Well Name: LOGAN 35 FEDERAL	Well Location: T17S / R27E / SEC 35 / NESE /	County or Parish/State: EDDY / NM
Well Number: 1	Type of Well: OIL WELL	Allottee or Tribe Name:
Lease Number: NMNM117806	Unit or CA Name:	Unit or CA Number:
US Well Number: 300153608100S1	Well Status: Producing Oil Well	Operator: REDWOOD OPERATING LLC

**Notice of Intent**

Type of Action Plug and Abandonment

## PLUG AND ABANDONMENT CONDITIONS OF APPROVAL

Redwood	PROPOSED	
Author:	Abby @ BCM	
Well Name	Logan 35 Fed	Well No. #1
Field/Pool	Red Lake; Glorieta-Yaso, NE	API #: 30-015-36081
County	Eddy	Location: Sec 35, T17S, R27E
State	New Mexico	1520' FSL & 1280' FEL
Spud Date	4/15/2008	GL: 3638

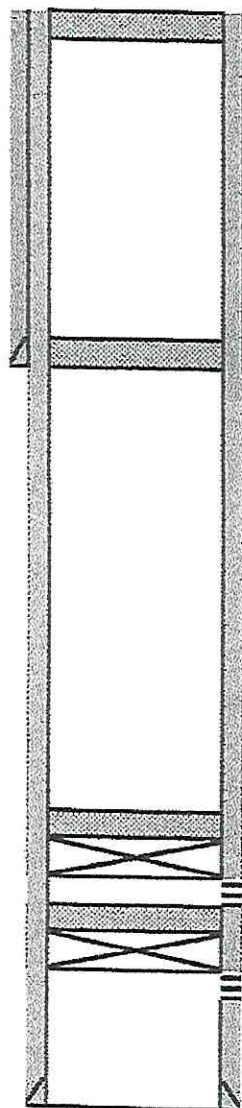
4. Spot ~~26~~ sx cmt @ ~~200~~' to surface.

55 SX 498

3. Spot 45 sx cmt @ ~~1200~~-845'. WOC & Tag (8 5/8" Shoe & Queen)

1230

2. Set 5 1/2" CIBP @ 1975'. Circ hole w/ MLF. Pressure test csg. Spot 25 sx cmt @ 1975-1775'. WOC & Tag.

1. Tag 5 1/2" CIBP @ 3020'. ~~Dump-bailed 35'~~ or spot 25 sx cmt @ 3020-2820'.

WCC ETAG

1. Set 5 1/2" CIBP @ 2991'. ~~Dump bailed 35'~~ or spot 25 sx cmt @ 2991-2791'. *woc & tag*
2. Set 5 1/2" CIBP @ 2006'. Circ hole w/ MLF. Pressure test csg. Spot 25 sx class C cmt @ 2006-1806'. WOC & Tag.
3. Spot 45 sx cmt @ 1230-850'. WOC & Tag (8 5/8" Shoe & Queen)
4. Spot ~~25~~ <sup>55</sup> sx cmt @ ~~200~~ <sup>448</sup>' to surface. *Verify @ surface.*
5. Cut off well head, verify cmt @ surface, weld on Dry Hole Marker.
